**Consolidated Terrain Analysis and
Hydrogeological Study Reports**
Greely Village Centre Subdivision
Part of Lot 73 and Part of Lot 74,
Registrar's Compiled Plan 902
Ottawa (Osgoode), Ontario

Report No. PH0145-07

PAGE
1.0 INTRODUCTION.....	1
2.0 RESPONSE TO COMMENTS	
2.1 COMMENTS BY GOLDR ASSOCIATES LTD.....	1
2.2 COMMENTS BY SOUTH NATION CONSERVATION.....	2

1. PH0145-1: TEST HOLE LOCATION PLAN
2. PH0145-2: LOT DEVELOPMENT PLAN
3. PH0145-3: PIEZOMETRIC HEAD DELINATION
4. PH0145-4: STRATIGRAPHIC CROSS SECTION A-A
5. FIGURE 1: LOCATION PLAN OF NEIGHBOURING
SAMPLING
6. FIGURE 2: GRAPHICAL ANALYSIS OF
MONITORING WELL DATA

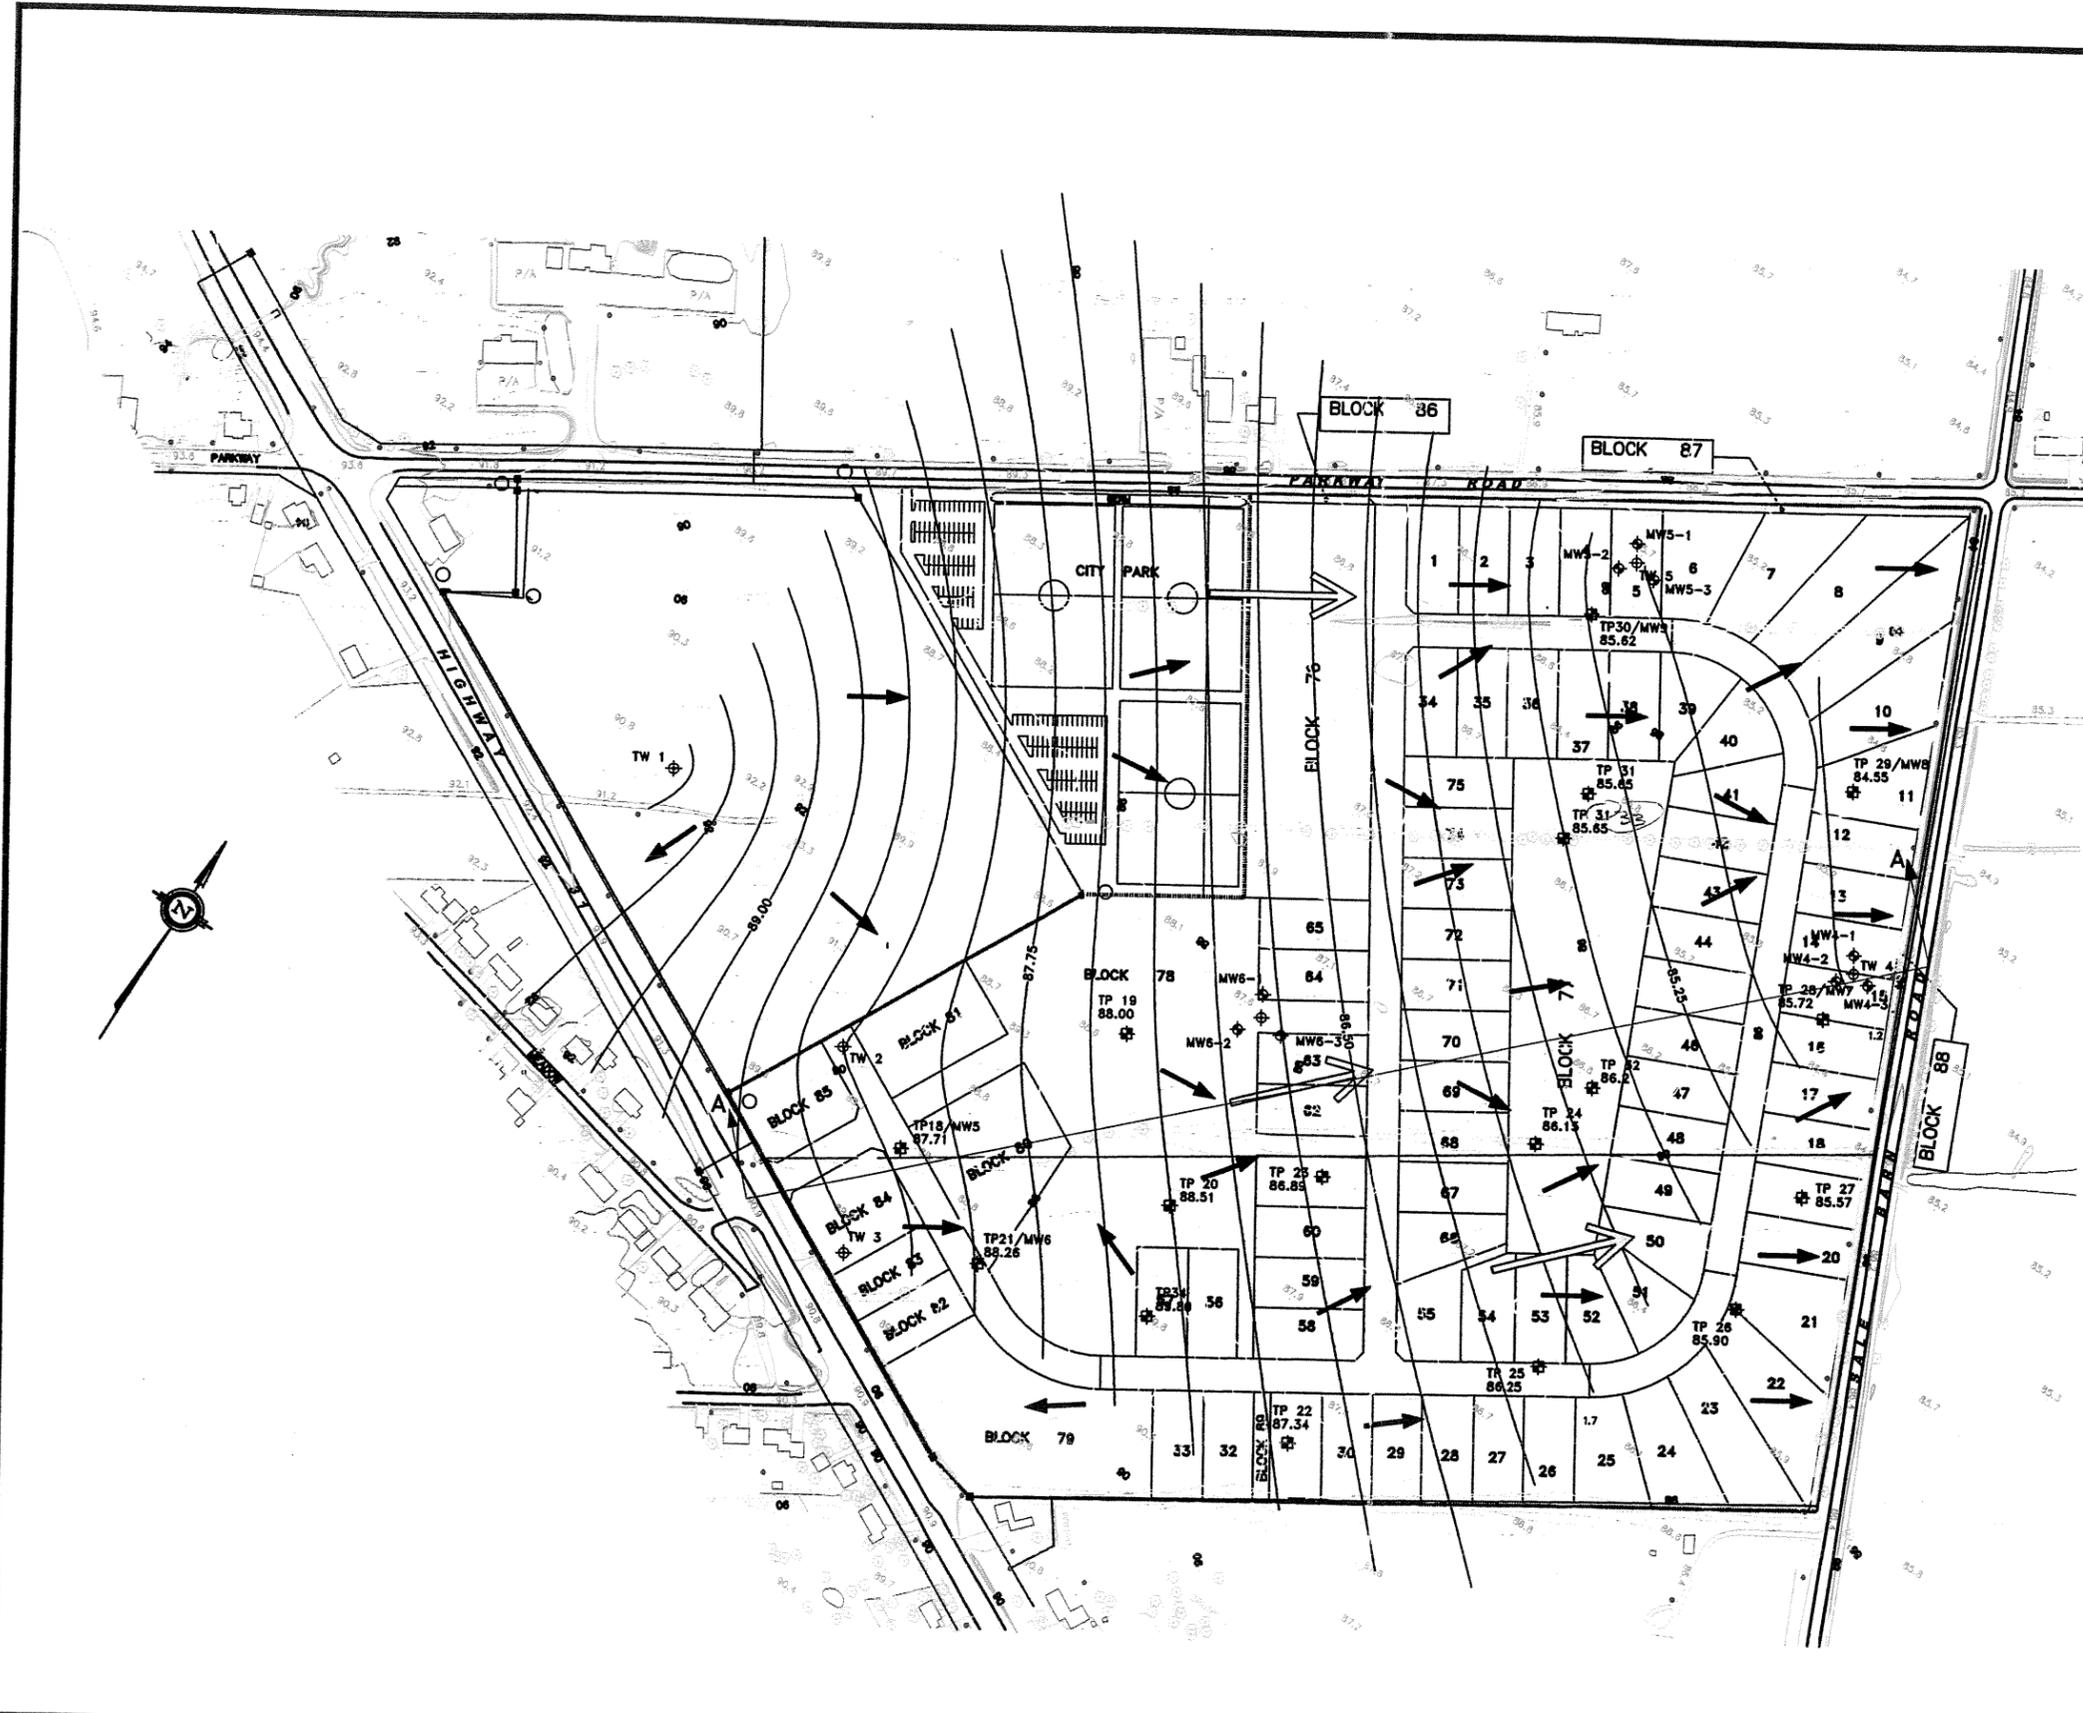
2.2.9 “The drawdown vs time graphs shown in the appendix 4 are missing identifiers for observation wells which were used for watertable monitoring during pumping of test wells. Observation wells/monitoring wells No. 1-5 are not mentioned in [the] report nor marked on figure PH0145-1.”

The revised original aquifer analysis information, as well as the aquifer analysis conducted on repeat pumping of TW4 and TW5 and the pumping of TW6, are all provided in Appendix 1. Furthermore, Drawing No. PH0145-1 has been revised to reflect all of the test well and monitoring well locations used in the confirmation testing for hydraulic isolation.
